TENNESSEE VALLEY AUTHORITY

January 11, 1980

RESPONSE TO L. S. RUBENSTEIN'S LETTER TO H. G. PARRIS
DATED OCTOBER 5, 1979
REVISED PER DECEMBER 17, 1979, TELEPHONE CONVERSATION
WATER LEVEL MEASUREMENT SYSTEMS INSIDE CONTAINMENT

STEAM FLOW INSTRUMENTATION - FIGURE 3

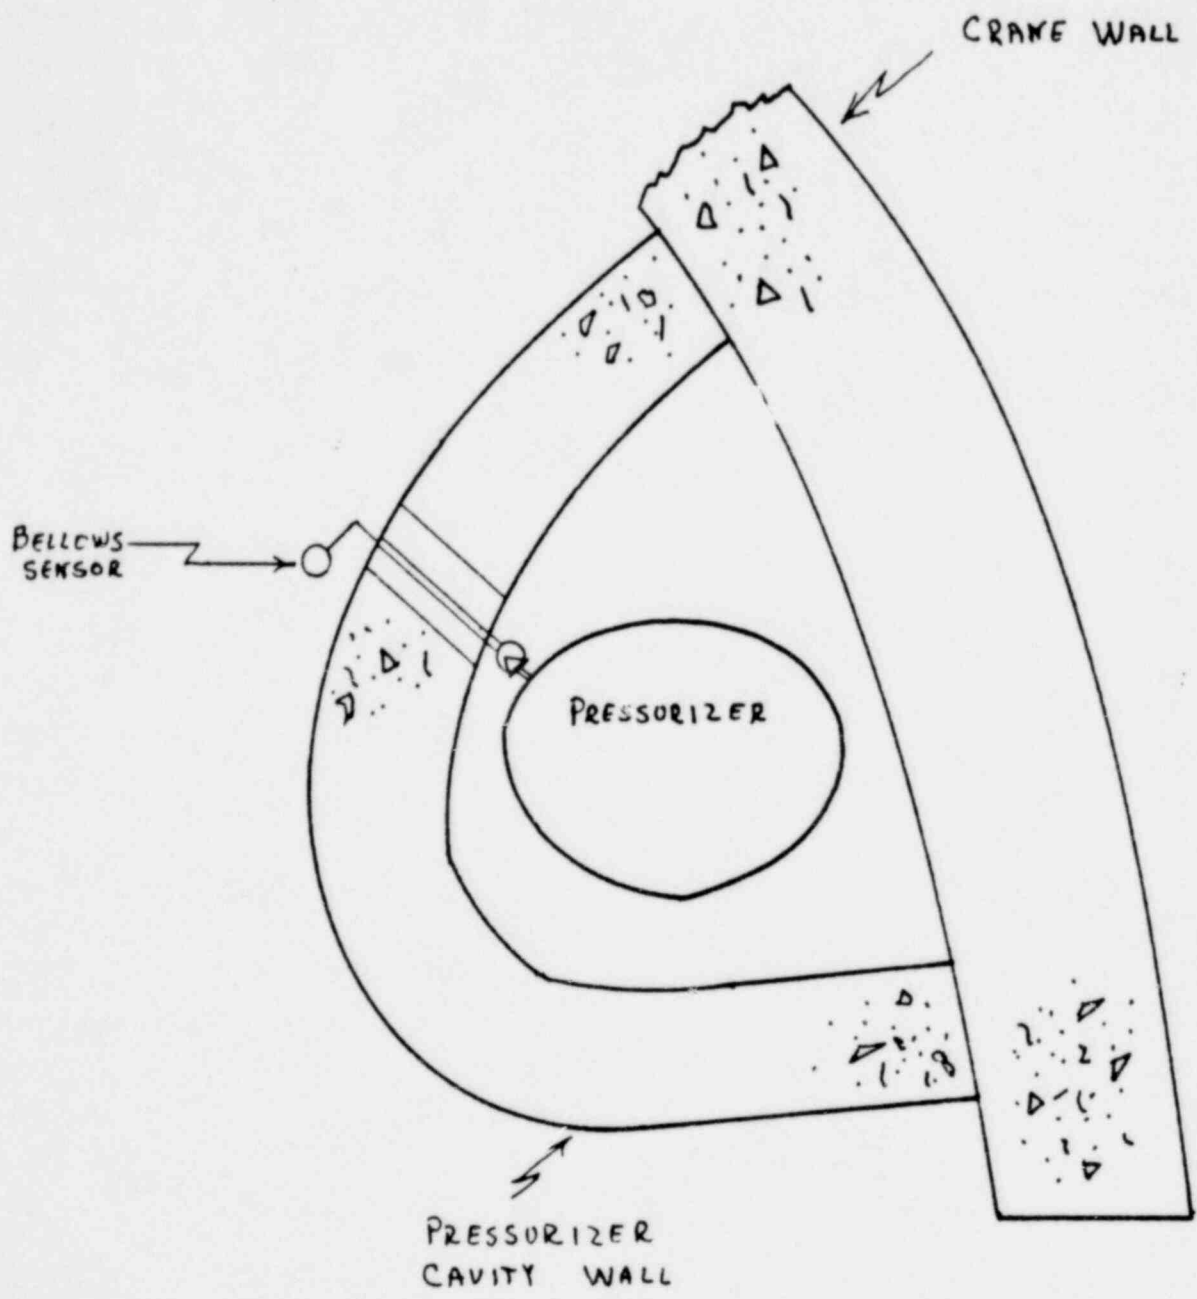
What are the temperature effects on the steam flow instrumentation?

The condensing chambers on the steam flow instrumentation are located 43 inches apart vertically as shown on figure 3. The effect of sense line heatup on steam flow measurement should be in the high flow direction since the low pressure side of the transmitter has a sense point 43 inches above the high pressure side. The sense lines would be expected to heat up at an approximately equal rate because of their close proximity. An equal heatup rate will cause an apparent high flow shift in the measured signal since the density of the 43-inch water column drops and puts a lower bias pressure on the low pressure side of the transmitter.

TYPICAL PLAN VIEW OF PRESSURIZER
UPPER TAP LEVEL MEASUREMENT
Figure 1

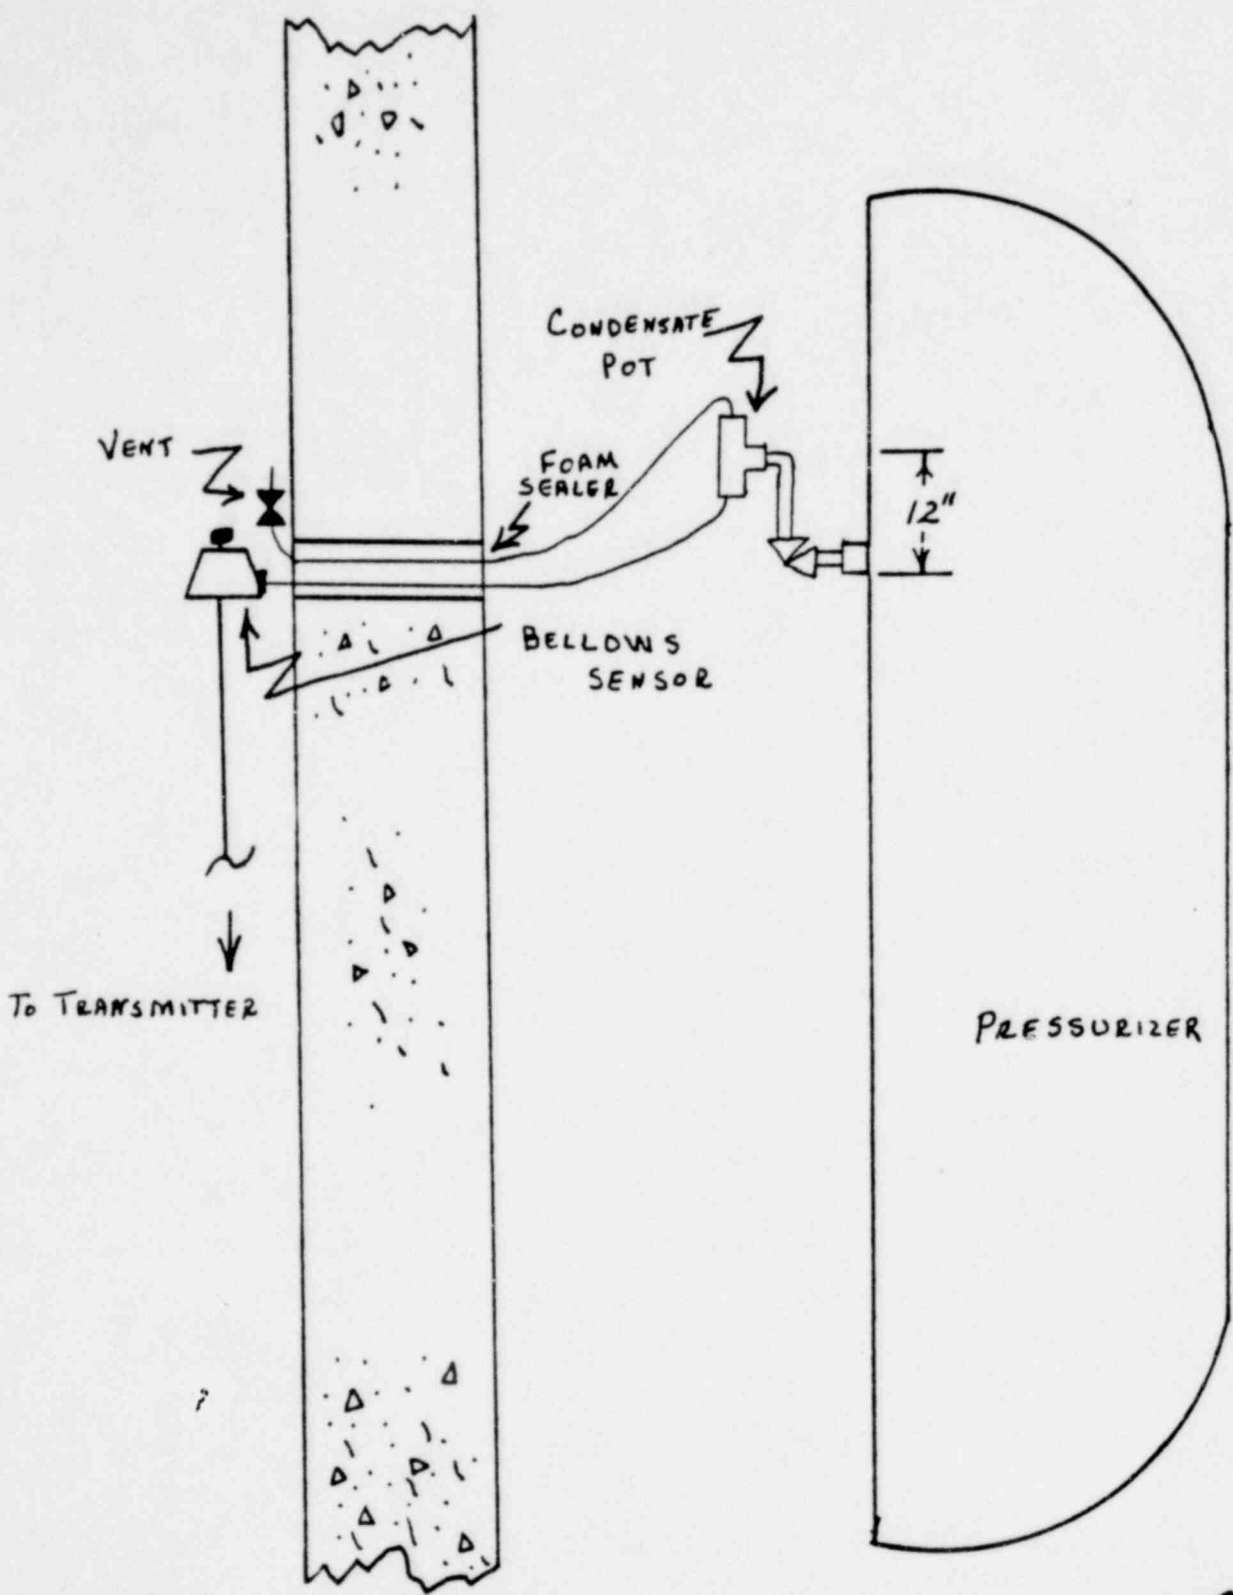
The bellows sensor is 12 inches below the condensate pot and even with the upper tap. This means if the sense line "boils" dry, there is a 4.3 percent error introduced because of reference leg height. Refer to figures 1 and 2.
